Global technical regulation No. YYY

TECHNICAL REQUIREMENTS *REGARDING*
AUDIBLE VEHICLE ALERTING SYSTEMS FOR QUIET ROAD TRANSPORT VEHICLES

As requested by the 3rd GTR QRTV Informal Working Group, the text below was prepared by OICA, as a compilation of specification on sound devices for the purpose of informing pedestrians about the presence of a vehicle. The table shows the documents used for the development of this text. The colours indicate in origin.

Diagram C:

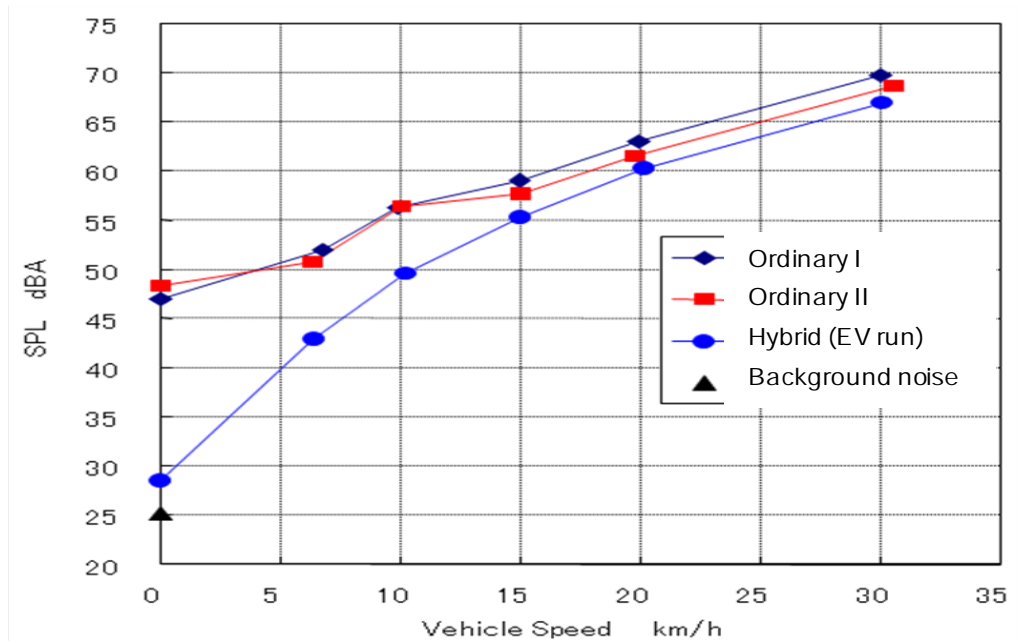
Japan may wish to update this chart
